**Marion County
Board of County Commissioners**

**PLANNING & ZONING SECTION
STAFF REPORT**

Public Hearing Dates	P&Z: 1/27/2025	BCC: 2/17/2025 and 2/18/2025
Case Number	250204SU	
CDP-AR No.	32251	
Type of Case: Special Use Permit	Office building and warehouse facility with outdoor material storage.	
Owner	Sumter Electric Cooperative, Inc. (previously Southern Hills Limited, Inc., Nan P. Bonfield, and Bryan Laura Trust)	
Applicant	Victoria Diaz, Bowman	
Street Address	12644, 12830, and 12940 SW 16 th Avenue	
Parcel Number	41200-012-00, 41200-020-00, and 41200-020-01	
Property Size	±39.20, ±20.00, and ±20.00 acres, totaling ±79.20 acres	
Future Land Use	Employment Center (EC)	
Zoning Classification	Community Business (B-2) [Based on an approval for Zoning Case No. 250203ZC representing ±39.20 acres of the ±79.20-acre site.]	
Overlays Zones & Special Areas	Outside Urban Growth Boundary (UGB), Marion Oaks/I-75 & Hwy 484 Urban Area, Secondary Springs Protection Zone (SSPZ), Marion County Utilities SW Service Area, and CR 475A Visual Enhancement Gateway Development Overlay (<i>CR 475A Overlay</i>)

Staff Recommendation	DENIAL	
P&ZC Recommendation	TBD	
Project Planner	Christopher D. Riso

**Figure 2
Concept Plan**

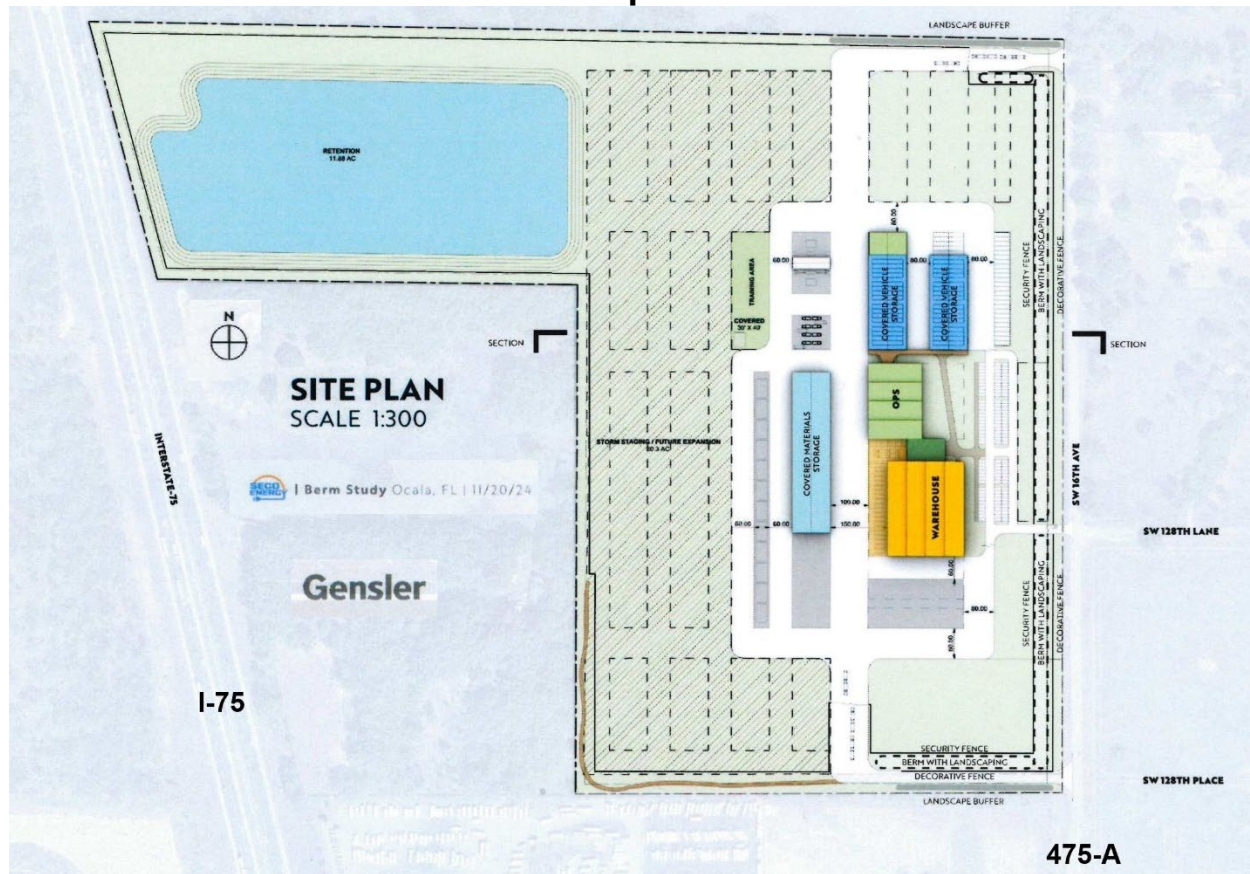
Staff notes that while the concept plan provided is “to scale” few, if any, specific measurements are indicated – primarily for vehicle driving aisles and a berm/buffer height along CR 475A. The plan proposes a series of buffers that focus along CR Hwy 475A and the eastern ends of the overall north and south site boundaries. No other buffers are indicated, particularly to the noted enclave area’s existing residences that face the rear of the site. Along CR 475A, a 3-foot high berm topped with 3-foot bush height as one of the few specific measurements indicated, along with what appear to be “trees” among the shrubs, presumably to satisfy Marion County’s required C-Type Buffer that must be increased to 20’ wide due to the site’s location in the CR 475A Overlay. No specifics are indicated for the limited buffers at the east ends of the north and south boundaries. Staff notes that the immediately adjoining properties north, south, and west are either developed with single-family homes and/or in agricultural use with General Agriculture (A-1) zoning. Commercial use of the site is required to provide a B-Type Buffer to single-family uses and a D-Type Buffer to agricultural uses; both the B-Type and D-Type Buffers require the provision of a minimum 6-foot high wall along the interior side of the buffer, and no wall is indicated by the concept plan. In regards to the proposed structures, while a berm and plantings are proposed along CR 475A, staff notes that the proposed warehouse would be in direct alignment with the buffer opening for the driveway aligning

with SW 128th Lane, so traffic at the future “intersection” would be able to view directly into the site to the warehouse structure.

The concept plan illustrates various parking areas and covered parking structures, along with sizeable on-site vehicle aisles that will be provided to support SECO vehicles and the necessary movements of products and materials around the “lay-down” yard. The concept plan notes that 8-foot high security fencing is proposed to control site access, and the placement of gates will need to comply with LDC requirements to ensure vehicles do not obstruct CR 475A traffic when queuing at the gates as well as providing for emergency access for emergency services.

The proposed SECO facility will include a significant outdoor storage “lay-down” yard that is not typically paved, but is instead stabilized, often with gravel and/or lime rock to an extent, which may lead to generating dust and noise as vehicles and equipment are delivered, removed, or re-arranged on the site which will generate noise as well with the site’s active access. Additionally, as a primary facility, the areas may be accessed at various times, including in the evening and/or overnight in the event of outages and/or emergency situations that may create significant light/glare impacts from the site. Immediately west of the main “lay-down” yard are three single-family homes where very little to no screening is currently present, and neither the concept plan or applicant’s findings propose any buffering to those residences or adjoining farms – wherein the LDC ordinarily requires either B-Type or D-Type Buffers that must include a minimum 6-foot high wall. The lack of buffer proposals for existing adjoining residences and/or farms is a significant deficiency for the proposal. Additionally, staff’s site inspection notes that the site includes varying elevations and appears to slope upwards from the existing residential enclave to the west. The placement of walls and/or berms along that shared boundary may then fail to adequately screen the activity to block noise, light, sound, and potential windborne dust/debris from the site being directed to the adjoining properties unless the wall and/or berms height is based on the site’s “lay-down” yard’s finished elevation that are unknown at this time. Staff recommends that this item has not been adequately addressed at this time.

The site consists of former farm properties with limited trees and screening vegetation; additionally, given the proposal for an ultimately extensive "lay-down" yard and the need to accommodate the maneuvering of vehicles, equipment, and stored materials, typical of such industrial-type storage yards, vegetation is discouraged which is a significant concern for staff. Aerial observations of a similar SECO Energy facility in Sumterville, FL supports this concern (see Attachment J). An extensive open area unobstructed by buffers or on-site vegetation may enable windborne dust and debris to be generated from the site. Further, as discussed in prior Item C, the lack of interior vegetation and complete buffers may enable noise, glare/light, and dust to be generated from the site, potentially affecting CR 475A, I-75, and particularly properties along the north and west boundaries where buffers including walls are ordinarily required by the LDC, representing a significant concern for staff. Staff recommends that this item has not been adequately addressed at this time.

outdoor storage “lay-down” yard, limiting the amount of managed open green space. Further, the unknown status of the site’s finished final grade elevations in regard to the surroundings is a concern for adjoining farms and residences. Potential setback and buffer areas are indicated, but no labels or dimensions are provided. For the CR 475A frontage, decorative board fence along with a minimum 3-foot high berm topped with 3-foot high shrubs, potentially viburnum odoratissimum (Sweet Viburnum) but unspecified, along with unknown “trees”. The timing of the hedge installation and size at time of planting is a concern, particularly given the open nature of site and the intended use of outdoor storage “lay-down” yard. Staff recommends that this item has not been adequately addressed at this time.

Analysis: The project will result in an extensive outdoor storage “lay-down” yard along with covered and/or enclosed warehouse structures along with a limited office. The buffering illustrated by the concept plan focuses on CR 475A but that timing/size of buffer installations is a concern. Further, no buffering details are provided for the site’s remaining boundaries to

8. The placement/layout of the proposed office, warehouse, and covered vehicle parking shall be revised to ensure that the site's central access aligning with SE 128th Lane (identified as Employee and Visitor/Vendor Access on the Traffic Methodology "Site Plan") consistent with one of the following options to ensure a non-monolithic structure is presented and visible to CR 475A as follows:

- a. The north-to-south order of the proposed office, warehouse and covered vehicle parking shall be reversed and/or revised to ensure the office is the primary structure centered on the central access aligning with SE 128th Lane, or

- b. The proposed warehouse shall present visually as a fully enclosed structure on its east, south, and north walls directed to CR 475A. No door/equipment openings shall be presented to CR 475A, while door/equipment openings for the north or south sides of the warehouse may be opened for active access and remain closed at other times to contain potential noise, etc. generated from within the warehouse. Further, the finished appearance of the warehouse shall not be a metal/corrugated siding or similar industrial appearance, with the north, south, and east facades architecturally finished to present a resemblance to an office type building, including apparent glass facades, and generally consistent with the intended office building.
